Initial Submission Review

WINDLER - MIDTOWN PHASE 1 LANDSCAPE & LIGHTING PLANS

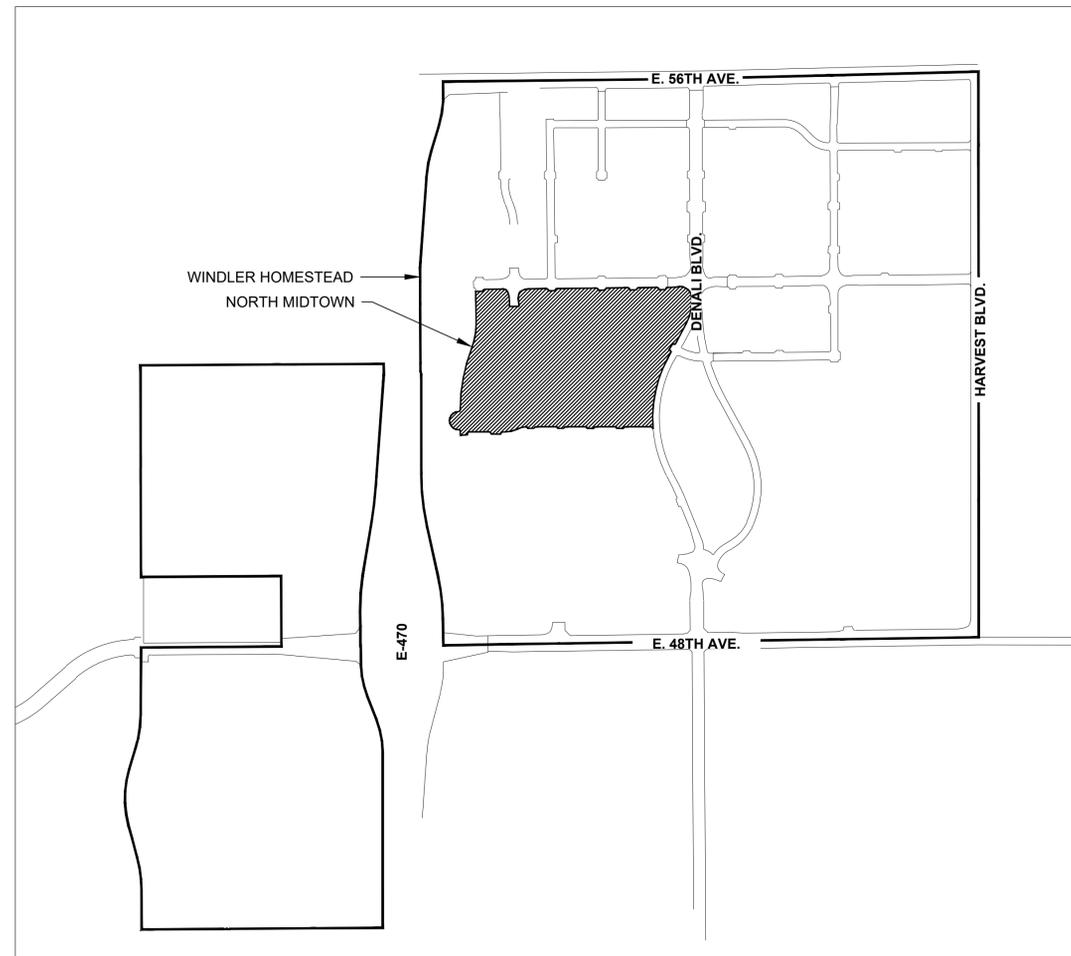
Update the sheet numbers to reflect just consecutive numbering 1, 2, 3.

These are not construction drawings. This aspect of the review process has not changed. These plans are just being submitted with the plat while the rest of the plan set is reviewed with the civil drawings.

Add "Not for Construction" to all landscape plan sheets.

SHEETS HAVE BEEN NUMBERED

PLAN SET HAS BEEN REVISED

ADDED

LAYOUT PLAN L1.4A

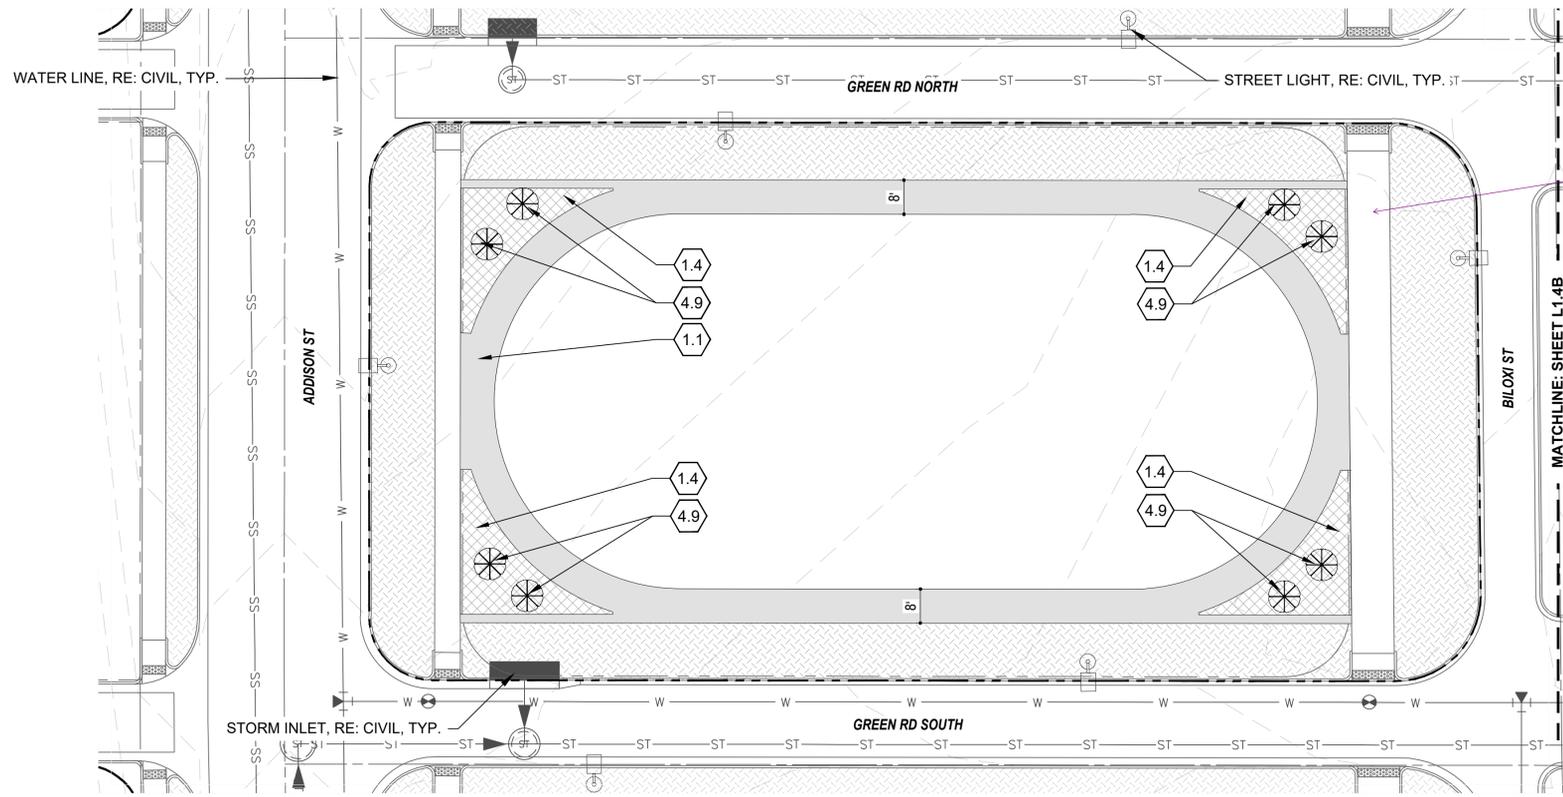
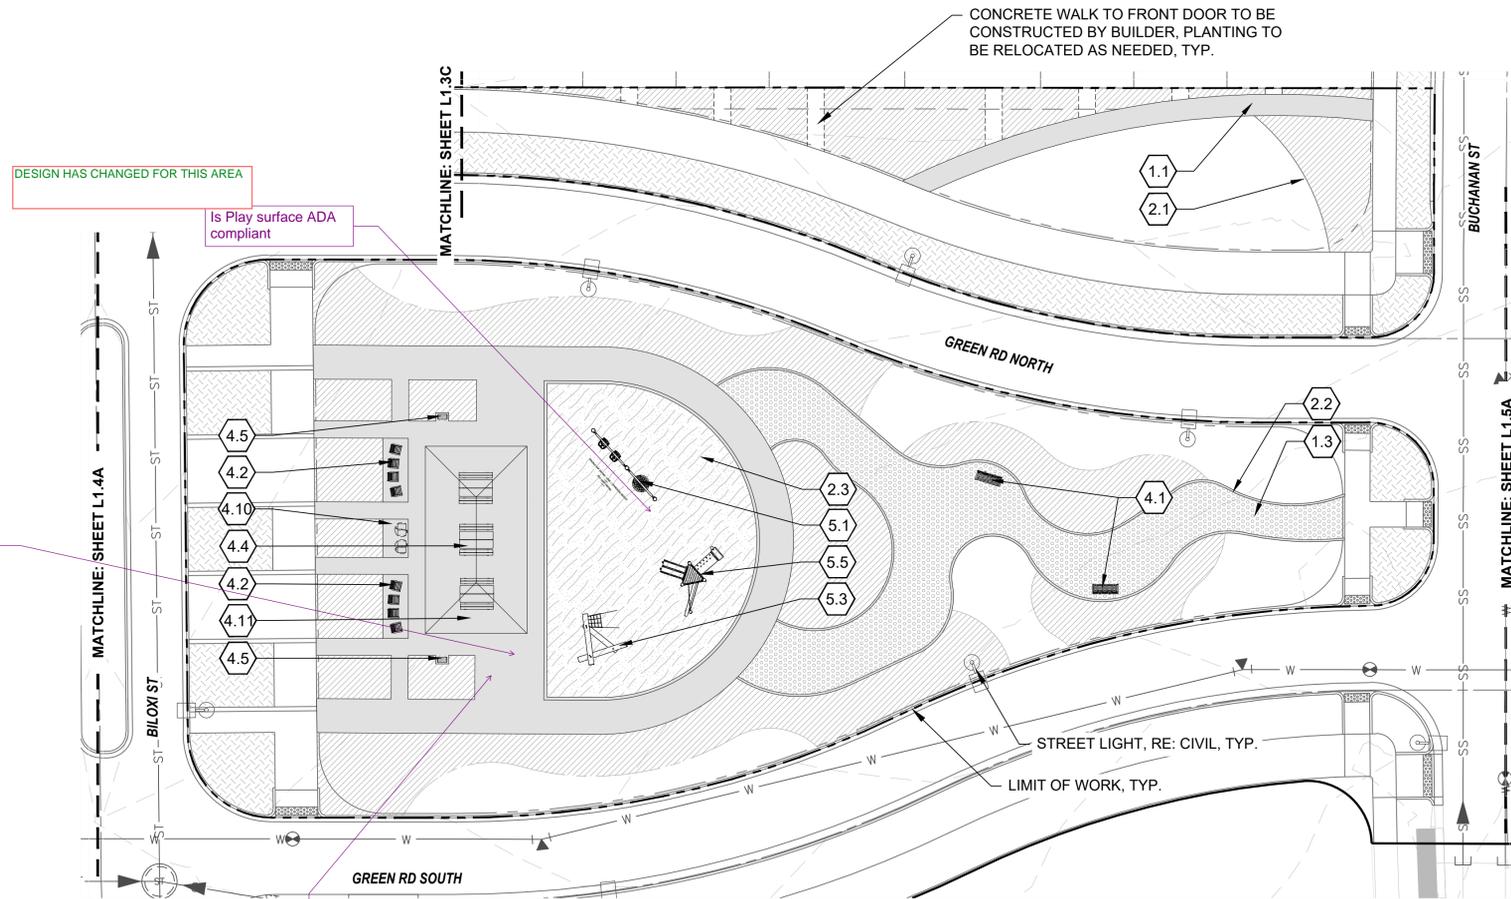
DESIGN HAS CHANGED FOR THIS AREA
include bike racks

LAYOUT PLAN L1.5A

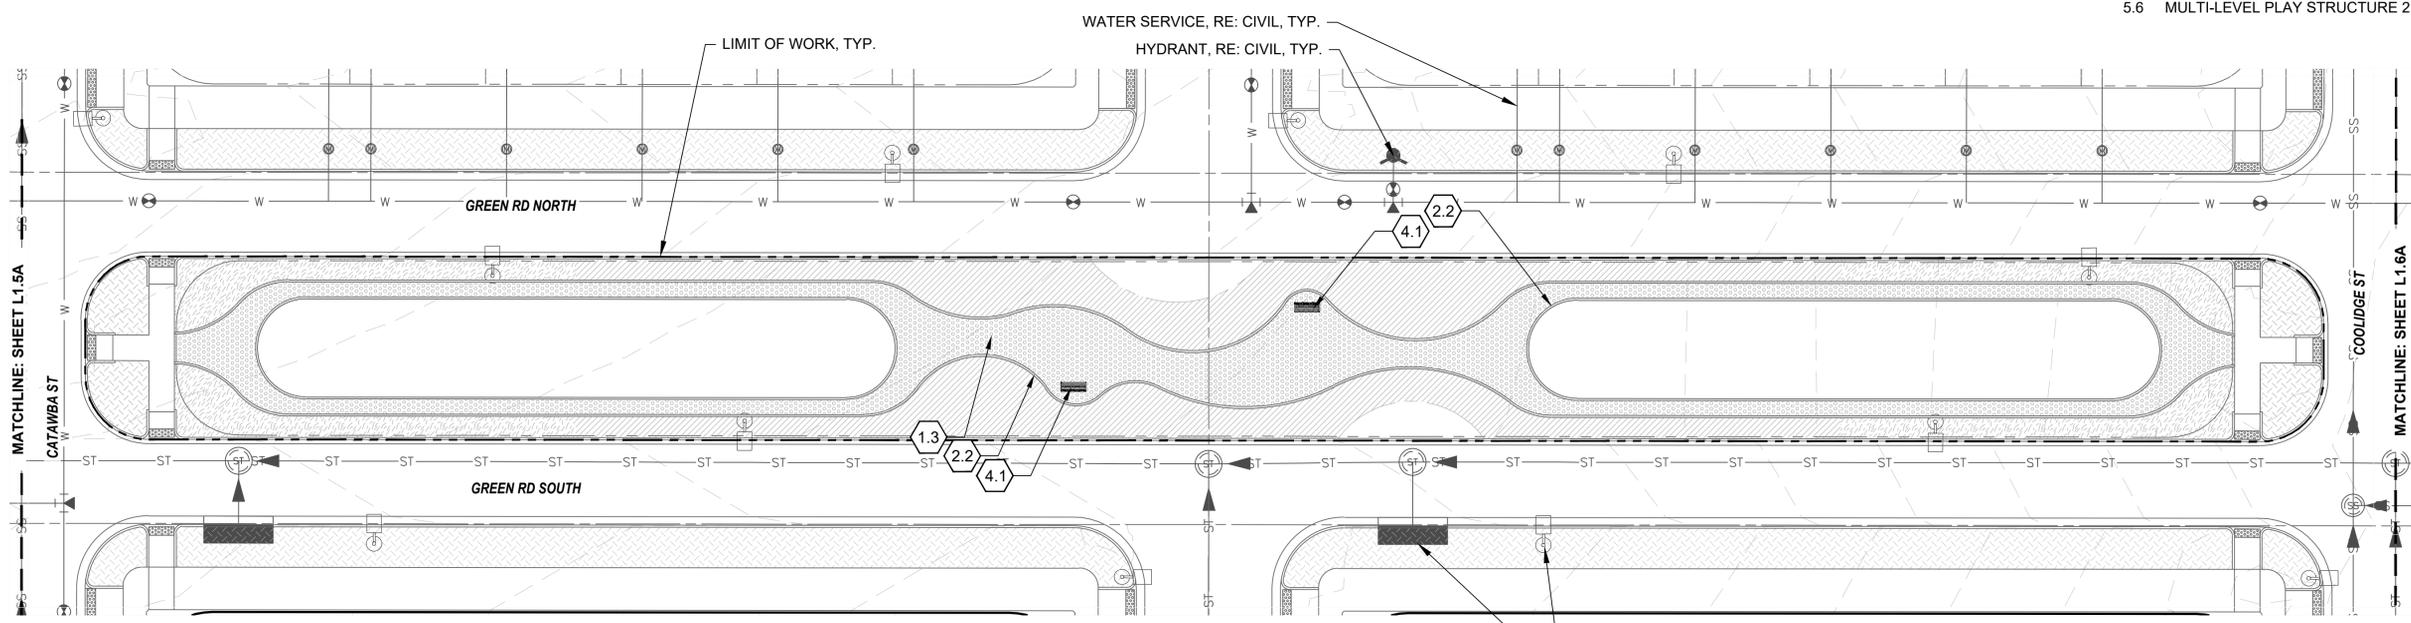
include bike racks
 BIKE RACKS HAVE BEEN RESERVED FOR AMENITIES THAT ARE EXPECTED TO DRAW HIGHER TRAFFIC AND/OR CONTAIN MORE ACTIVE USES

LAYOUT PLAN L1.8B

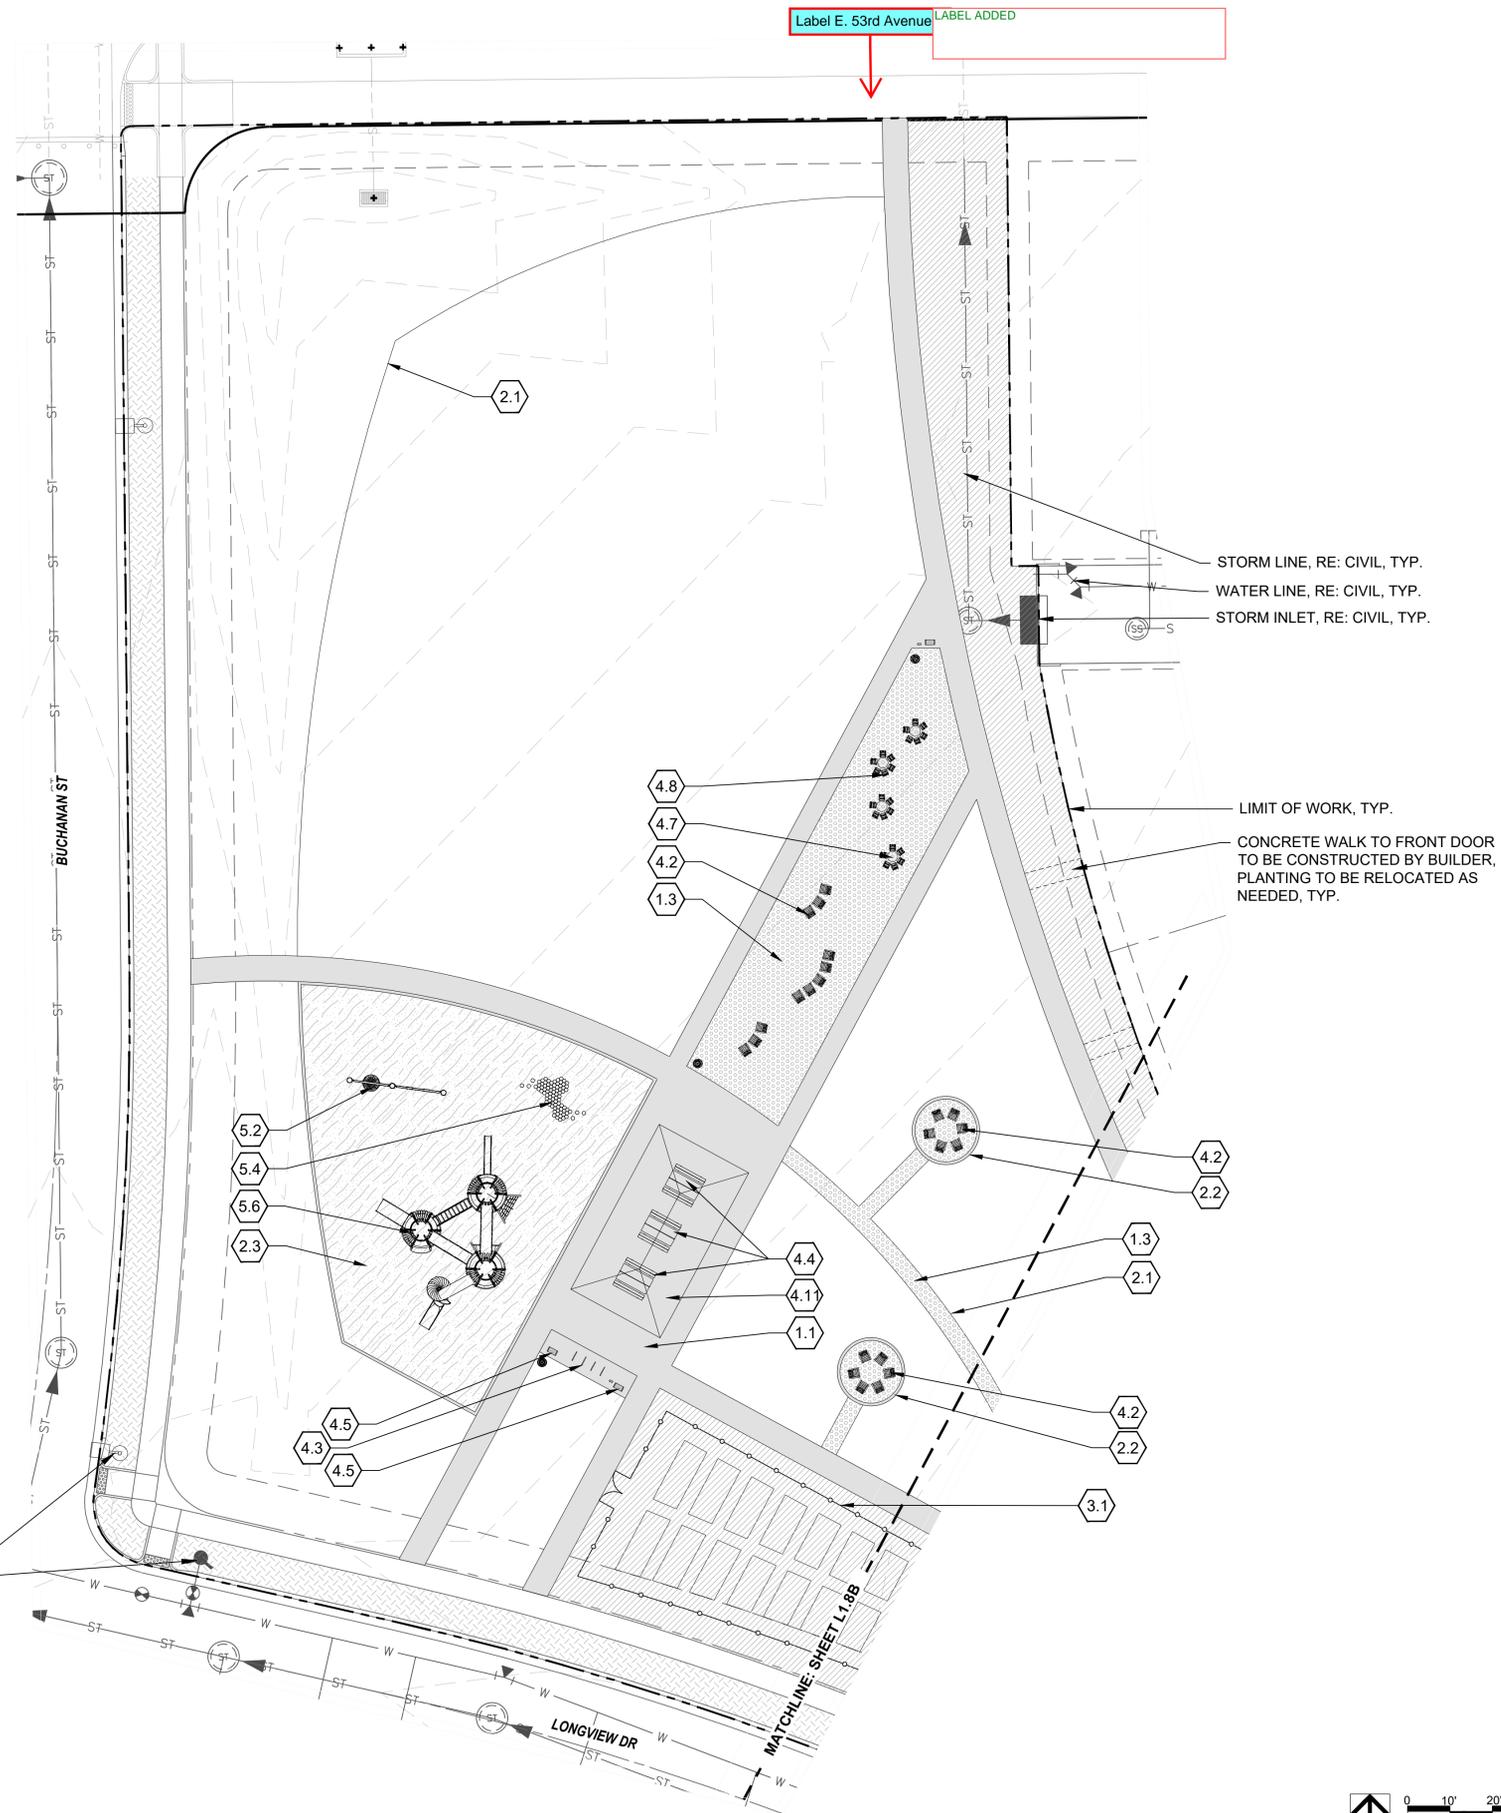
Include more waste stations and dog waste stations on all open space tracts
 ADDITIONAL WASTE BINS AND DOG WASTE STATIONS HAVE BEEN ADDED THROUGHOUT

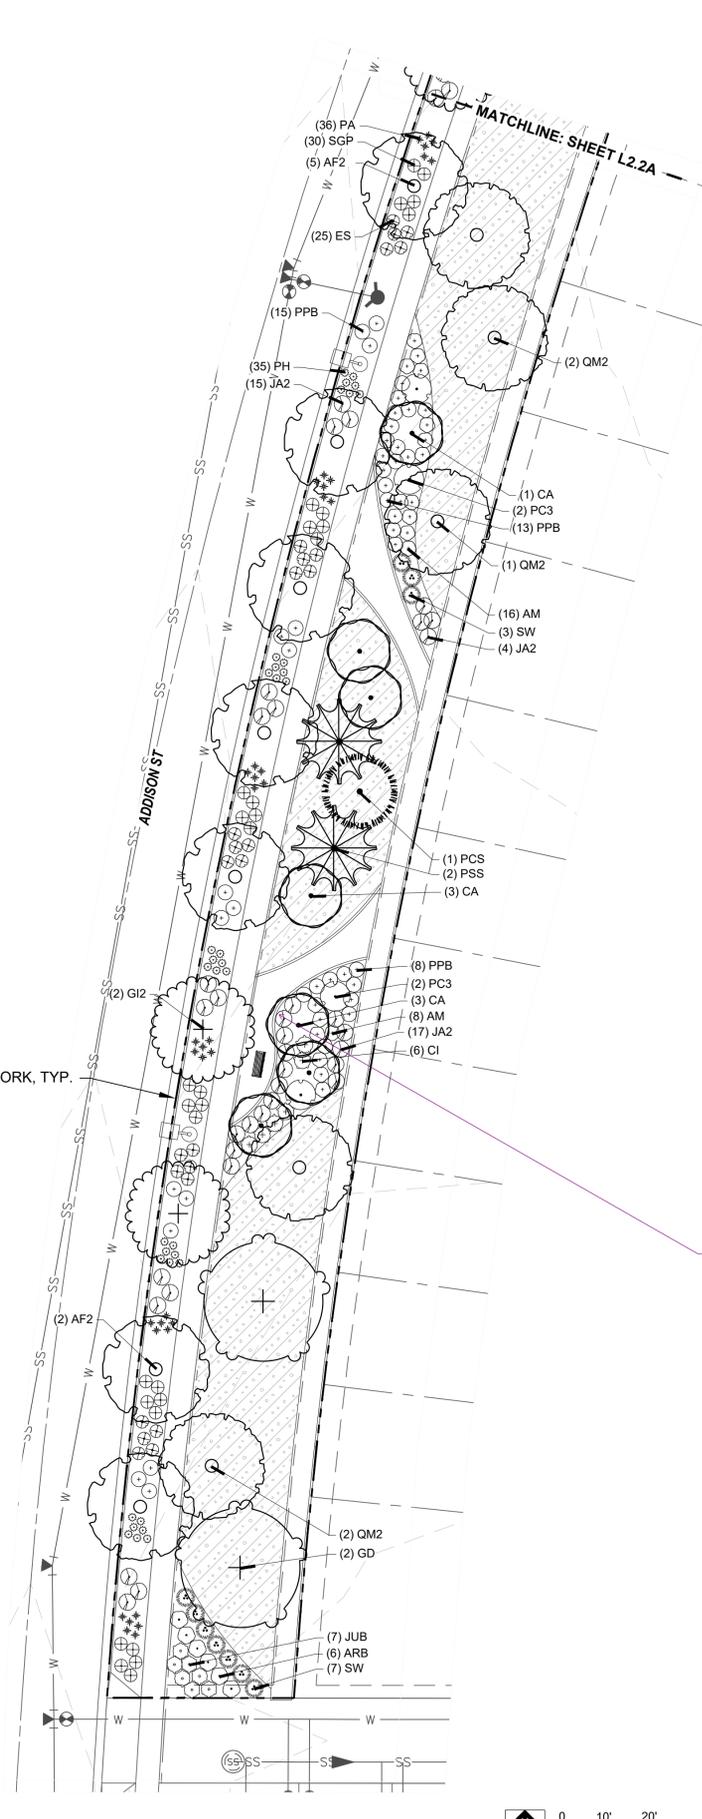
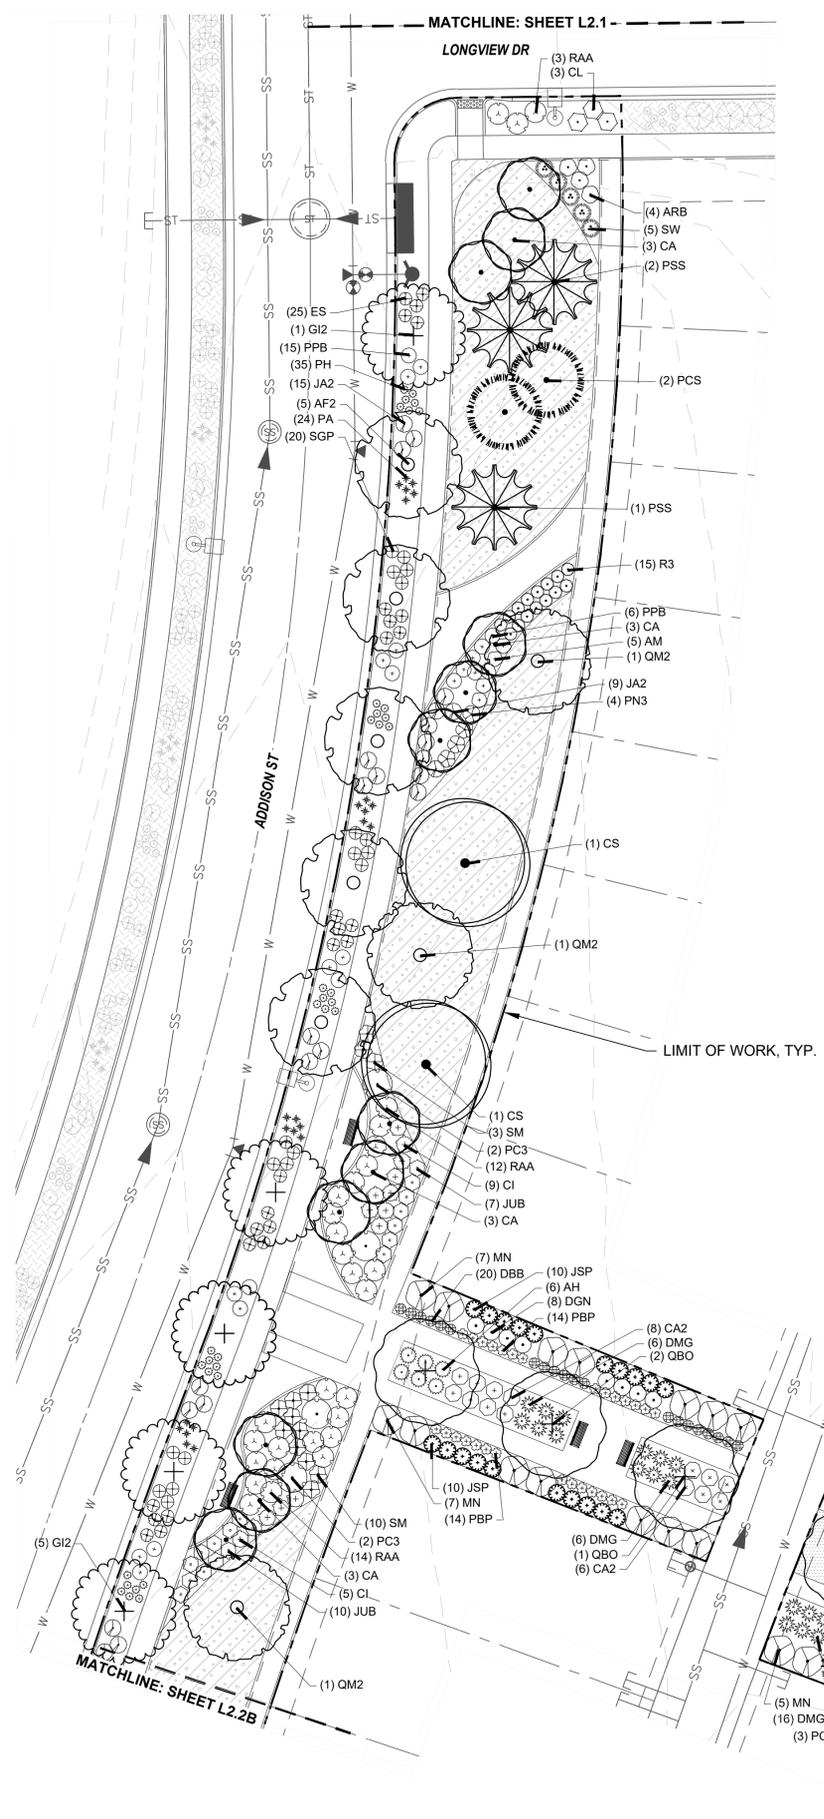
with Tim York in Aurora water if these areas designated for sod will be permitted. This should be confirmed before irrigation plans are submitted for review or these areas may be denied and then a mylar change to these plans will be necessary to remove the sod and replace with other landscaping.

WE HAVE COORDINATED PROPOSED TURF LOCATIONS WITH TIM YORK AND HAVE REVISED OUR PLANS AS REQUESTED
